APPROVED MINUTES

January 19, 2023 Standards Committee Meeting

RE: Minutes from the January 19, 2023 Standards Committee Meeting

REVISION TO 2022 STANDARD SPECIFICATIONS AND STANDARD DRAWINGS

E 714-BCJT-01 PRECAST REINFORCED CONCRETE SECTION JOINTS (PROPOSED DRAFT)

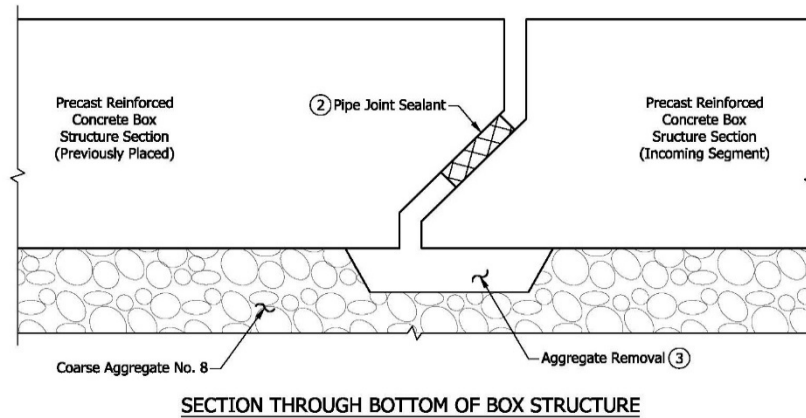
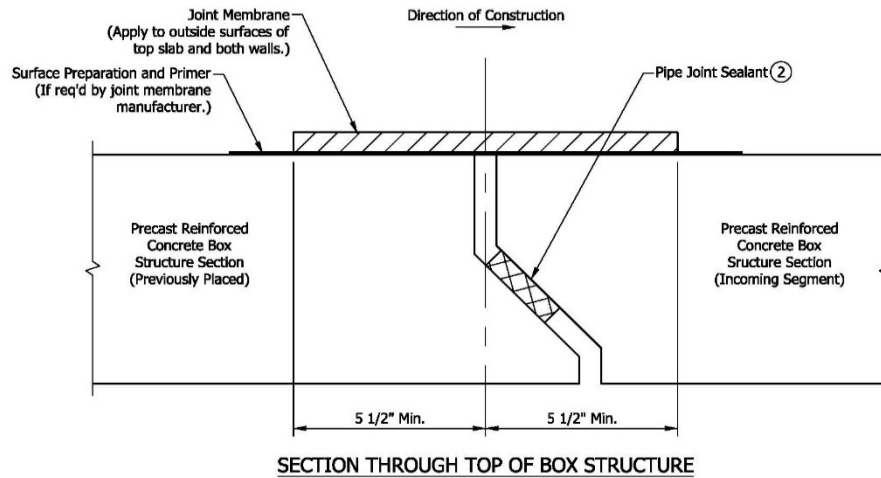
PROPOSED SOLUTION: Incorporate the proposed changes which clarify the material(s) to be placed between joints in precast concrete box and three-sided culvert sections. Also clarify and update the material used to wrap the exterior of the joint shall be in accordance with an ASTM spec.

Mr. Reilman proposed to incorporate the proposed changes which clarify the materials to be placed between joints in precast concrete box and three-sided culvert sections. Also clarify and update the material used to wrap the exterior of the joint shall be in accordance with an ASTM spec.

Mr. Koch asked, with regard to 714.10(b) and 723.14(b), where it states "both sides of every joint", for added clarity should 'exterior' be added?

Mr. Reilman responded that we do have standard drawings to accompany the 714 and 723 revisions. However, I agree with you in that "exterior" could be added as you note below for added clarity.

Language was revised for clarification and Mr. Reilman revised his motion. Mr. White seconded the motion.

E 723-TSJT-01 PRECAST REINFORCED CONCRETE THREE-SIDED STRUCTURE SECTION JOINT (PROPOSED DRAFT)

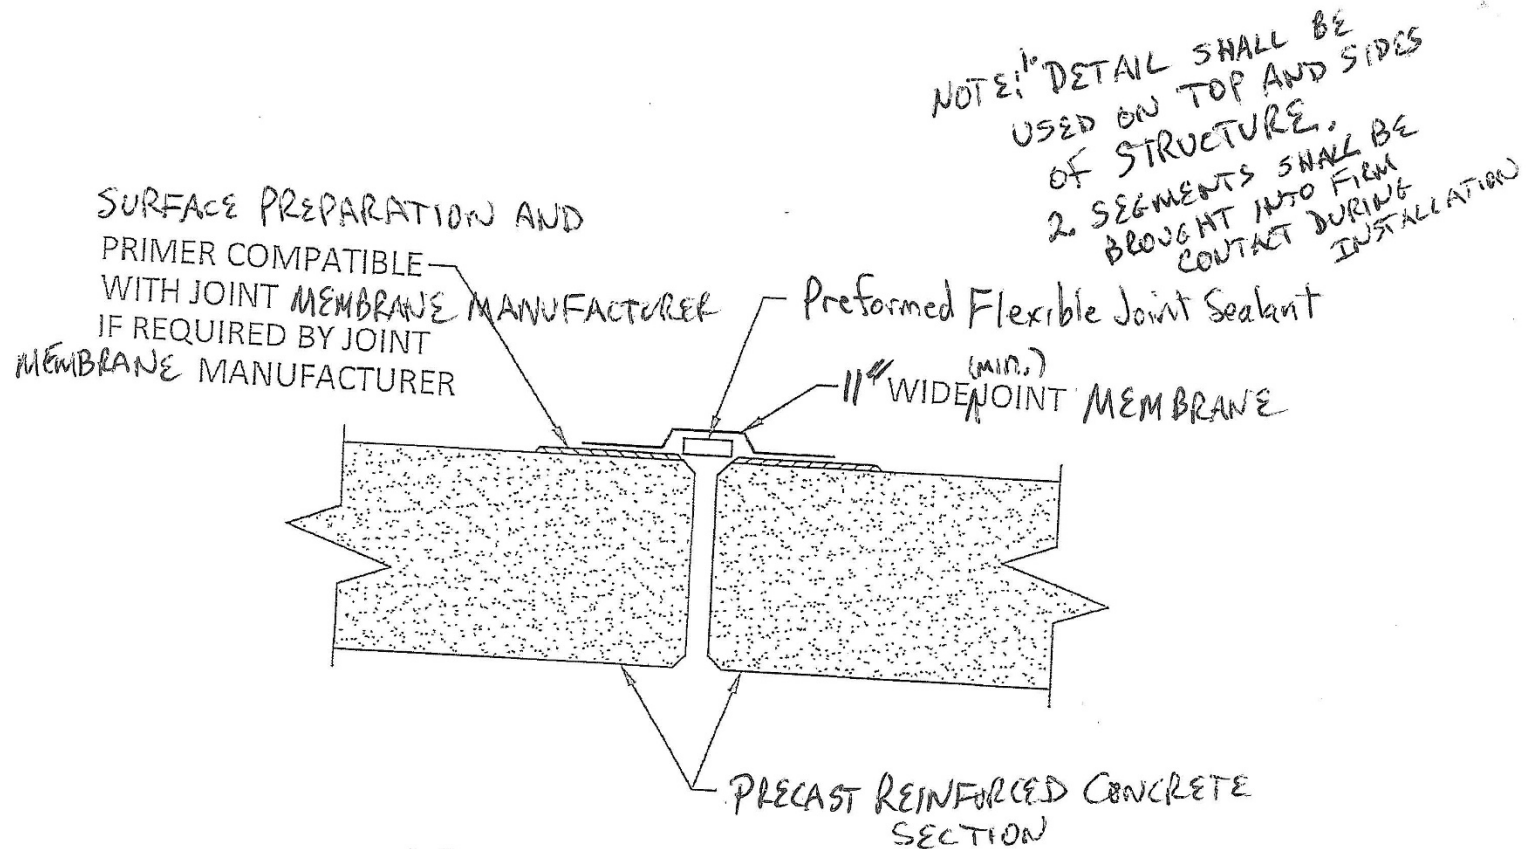
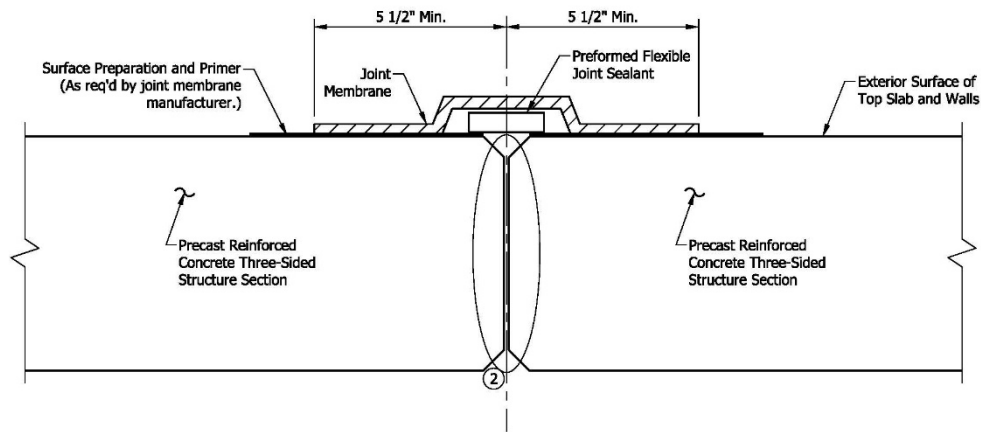
Outside of the meeting, Steve Smart asked about Note 2 on the standard drawing for the three-sided structures (Segments shall be brought into firm contact during installation). Mr. Smart asked "what is INDOT's expectation of firm contact?". Mr. Reilman responded that the expectation is that the sections will be pushed together as much as possible until they no longer move.
